REVISED SITE DEVELOPMENT PLAN - RETAIN EXISTING ANTENNA RANGE AND PARKING LOT FI

JOHNS HOPKINS APPLIED PHYSICS LAB NORTH PARKING / BALL FIELD ENTRANCE

REVISED SHEET INDEX AND ADDITIONAL NOTES

NO AS-BUILT ONTHIS SHEET SDP-04-66

REVISED DRAINAGE AREA A PLAN

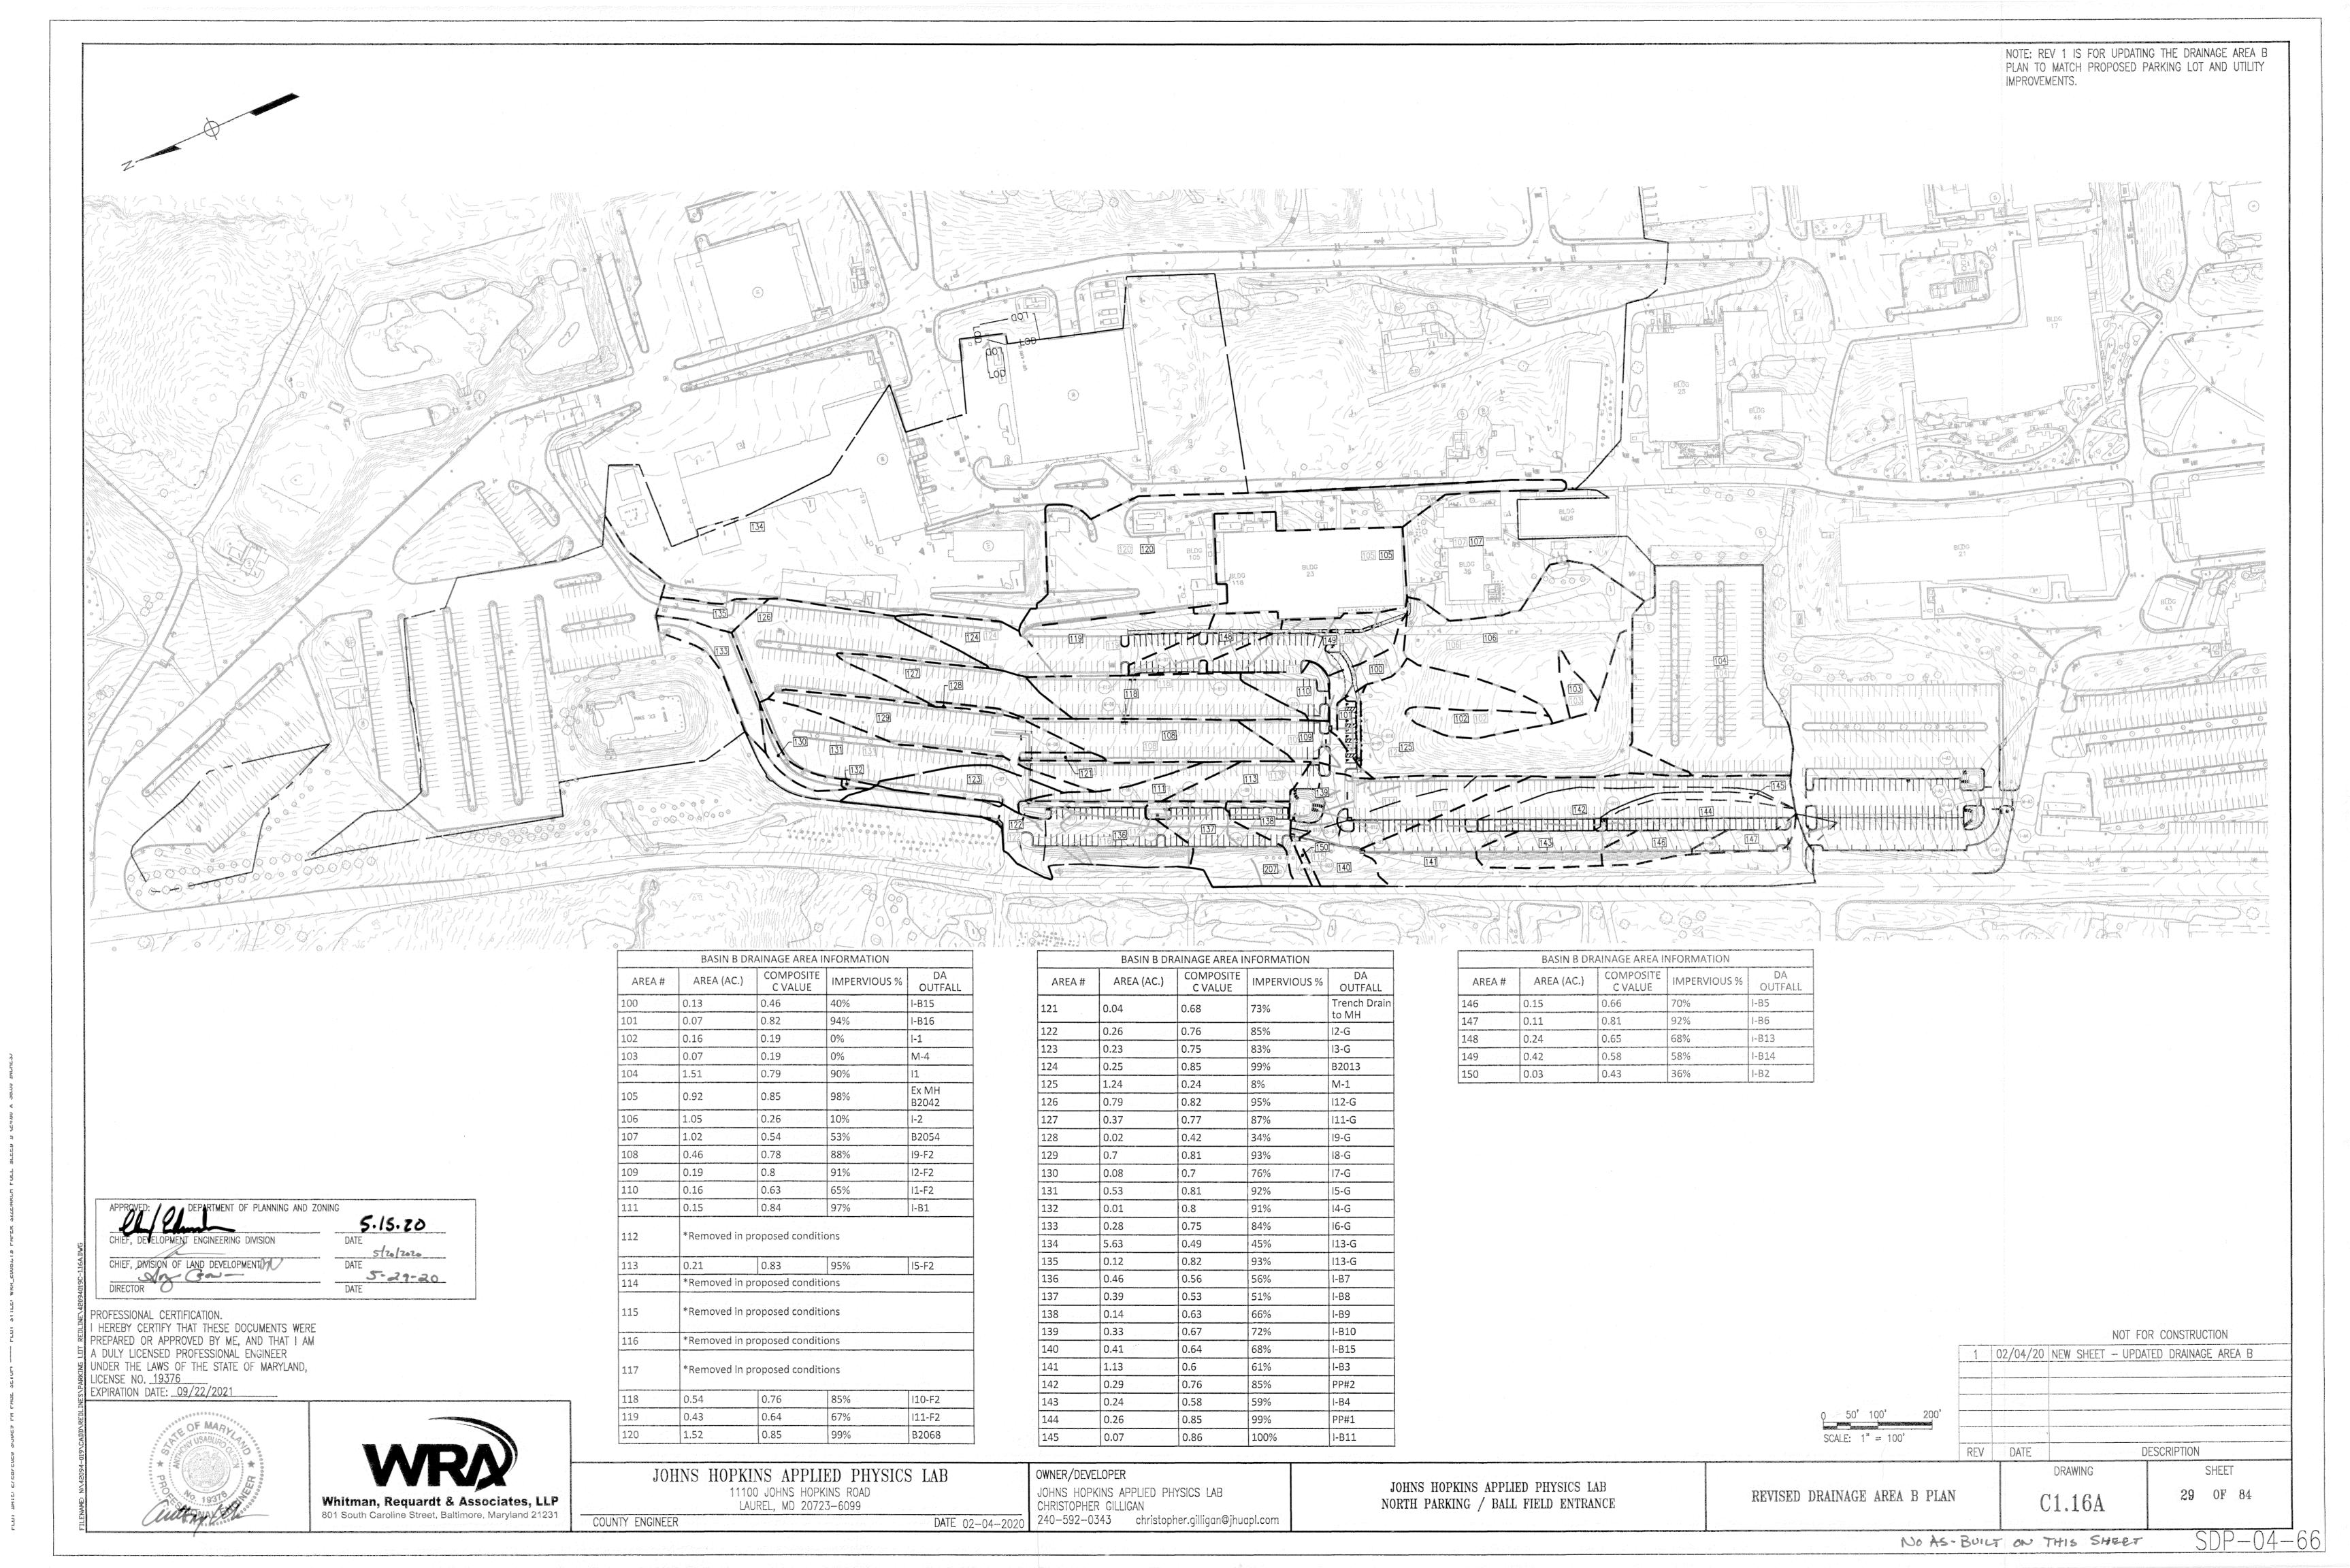
1 02/04/20 NEW SHEET - UPDATED DRAINAGE AREA A

NOTE: REV 1 IS FOR UPDATING THE DRAINAGE AREA A PLAN TO MATCH PROPOSED PARKING LOT AND UTILITY IMPROVEMENTS.

JOHNS HOPKINS APPLIED PHYSICS LAB NORTH PARKING / BALL FIELD ENTRANCE REVISED WATER MAIN PROFILE

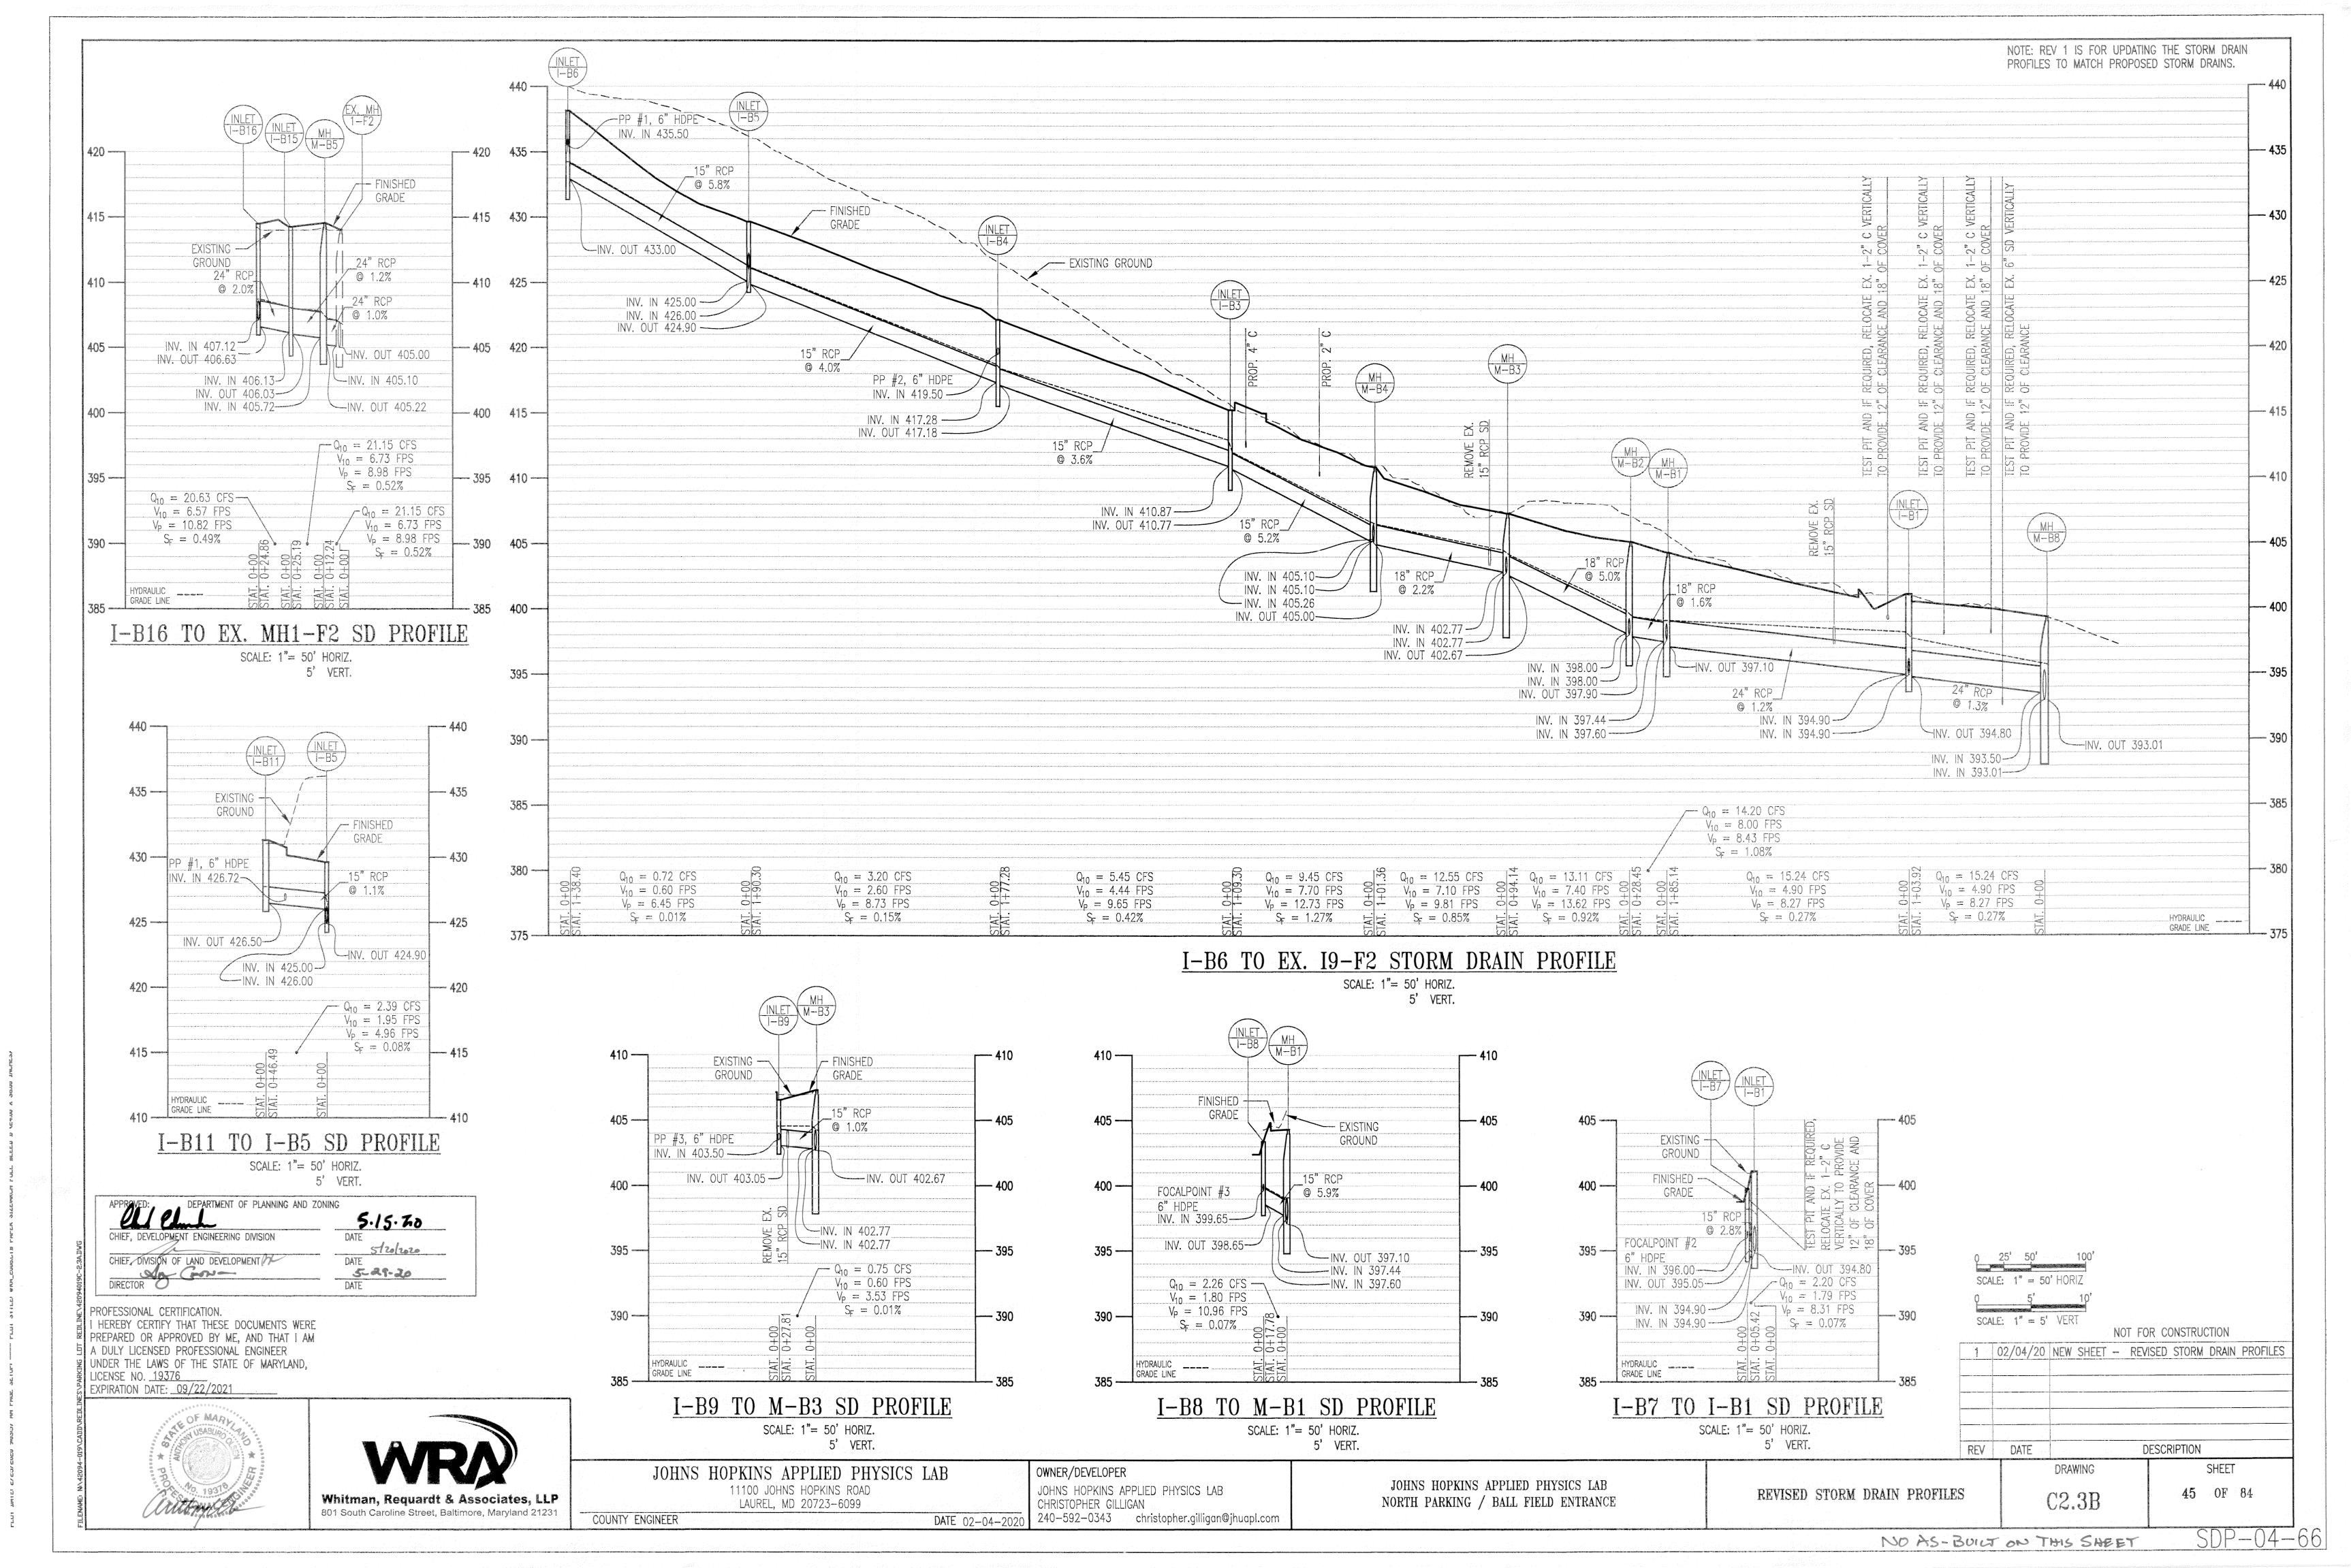
NOTE: REV 1 IS FOR UPDATING THE WATER MAIN PROFILE TO MATCH PROPOSED WATER MAIN.

1 02/04/20 NEW SHEET - REVISED WATER LINE PROFILE

REVISED R-TANK SPECIFICATION

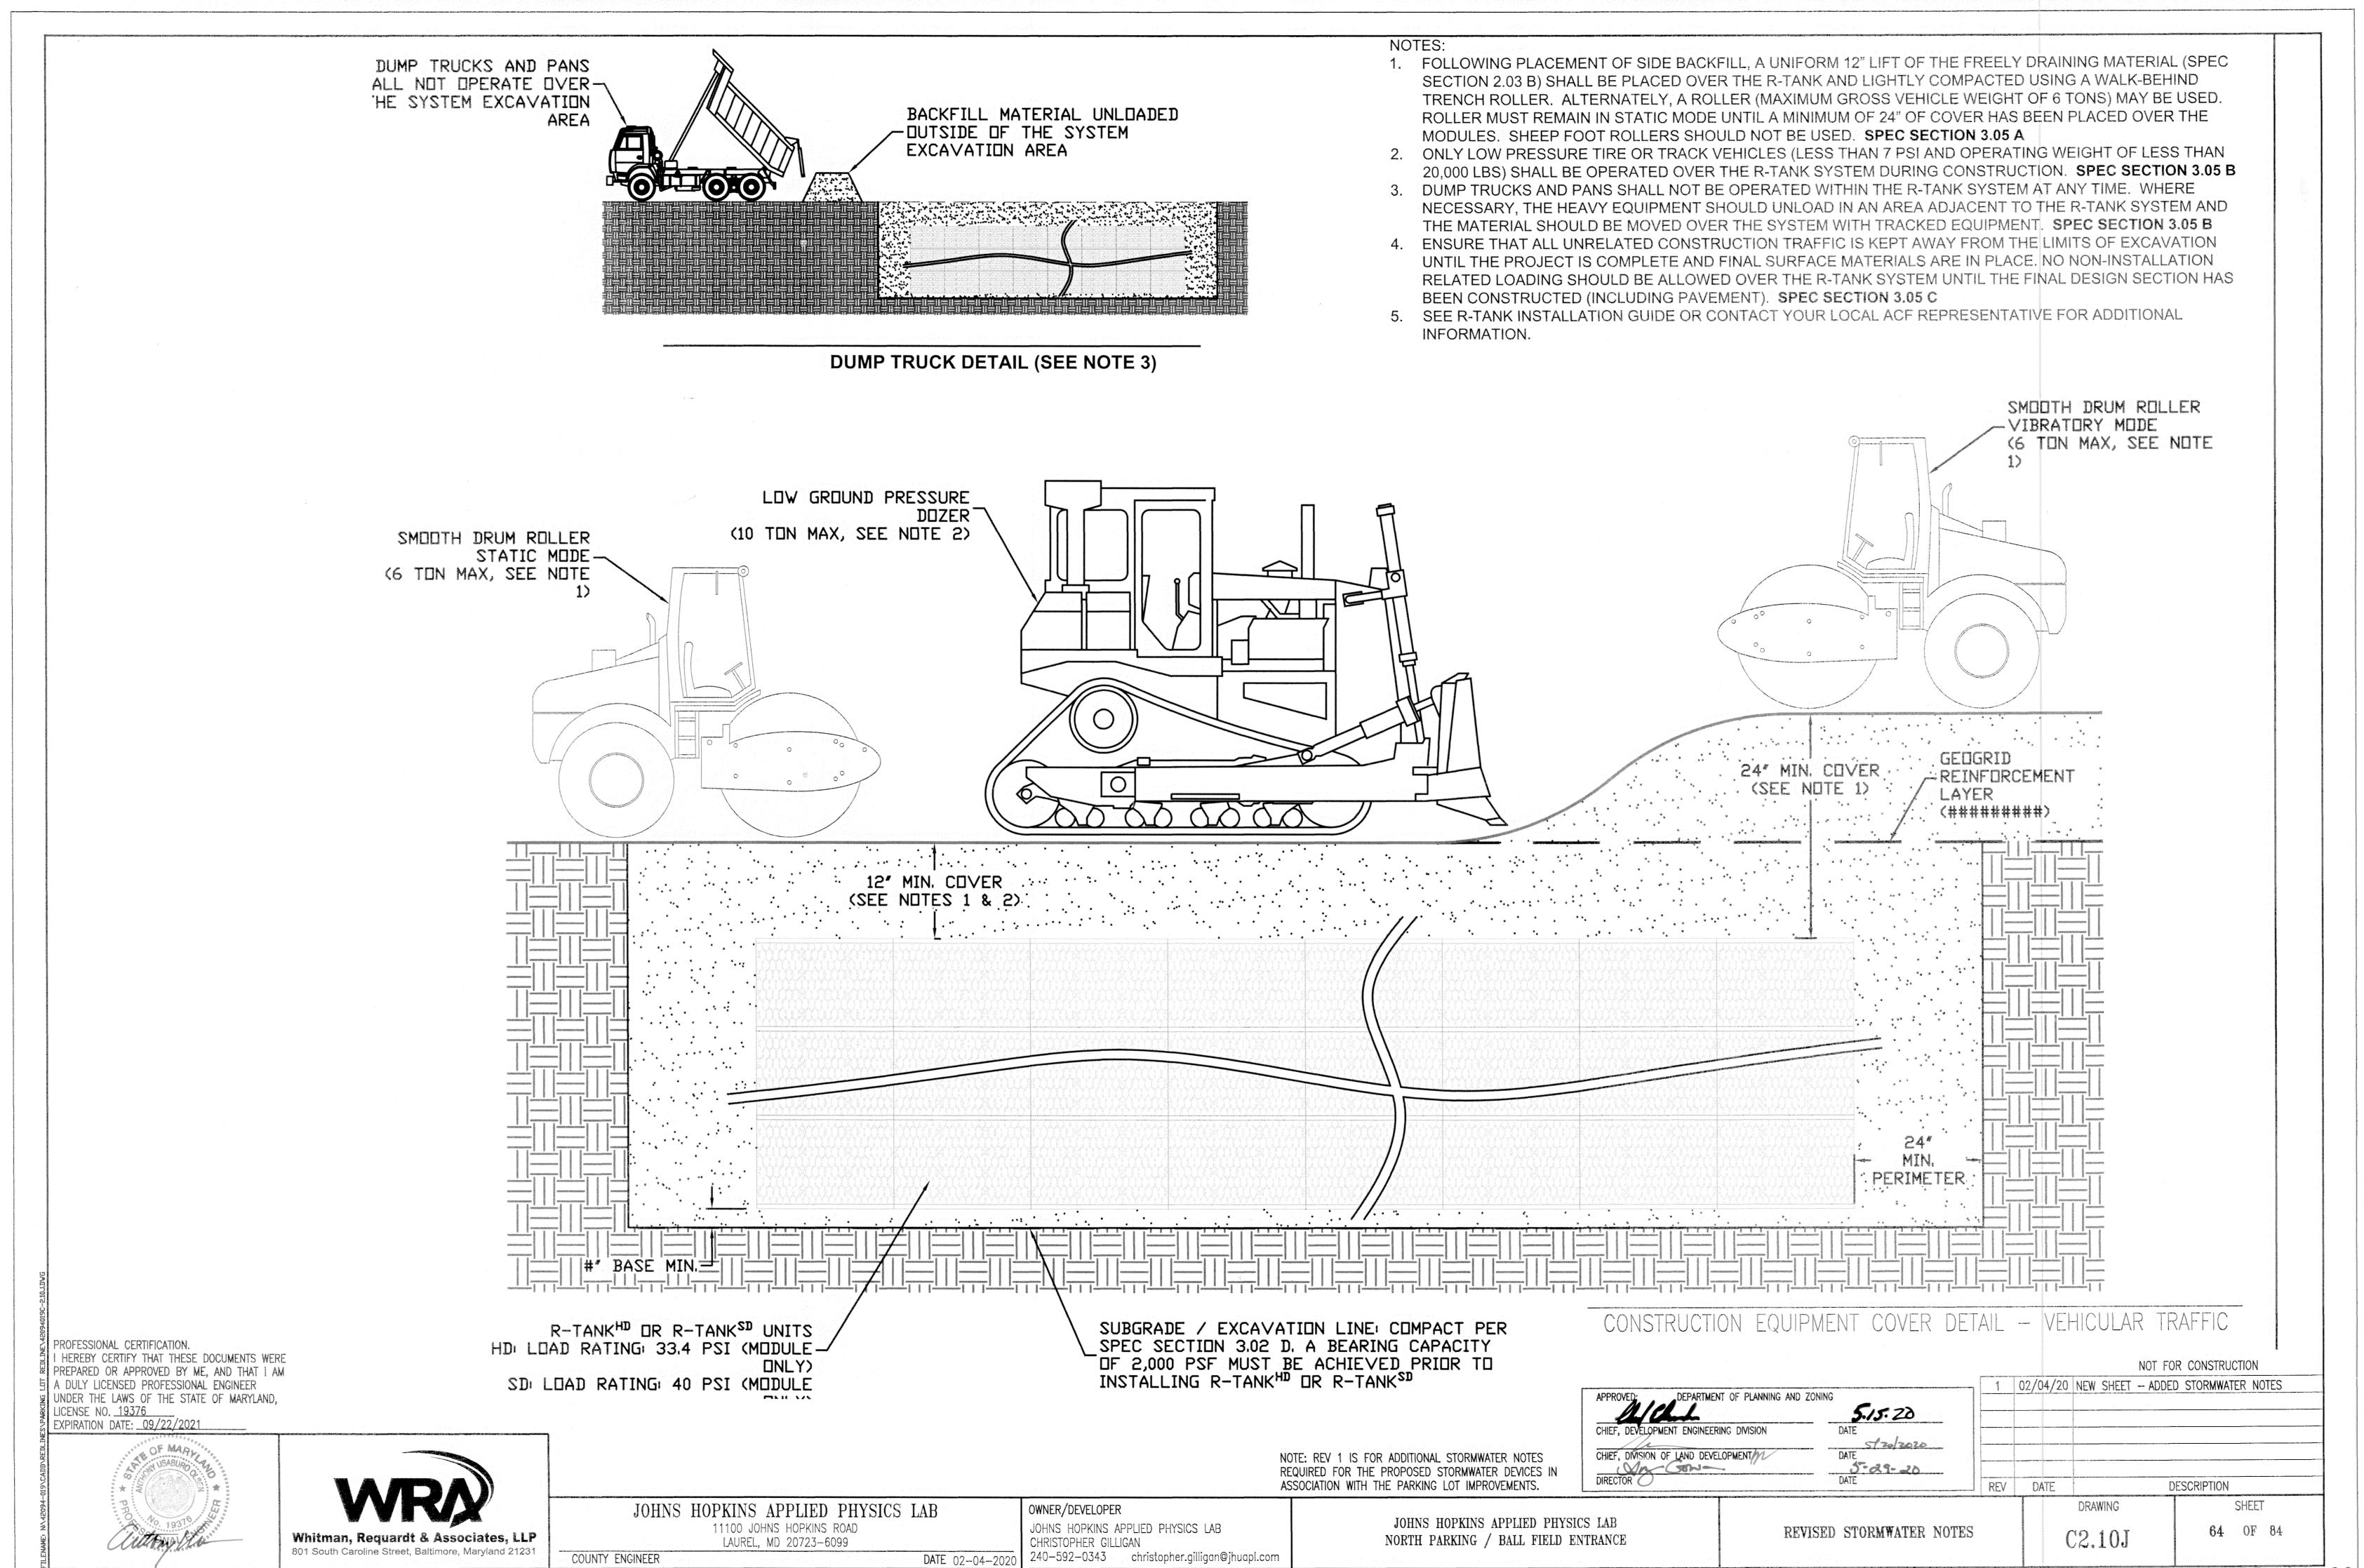
1	02/04/20	NEW SHEET -ADDED	SPECS FOR R-TANK SY	STEM
NOTE: REV 1 IS FOR ADDITIONAL R-TANK SPECIFICATION					
REQUIRED FOR THE PROPOSED STORMWATER IN					
ASSOCIATION WITH THE PARKING LOT IMPROVEMENTS.	REV	DATE		DESCRIPTION	
			DRAWING	SHEET	finitionalismostanicismostanicismos
REVISED R-TANK SPECIFICATION	)N		TO LOD	63 OF 84
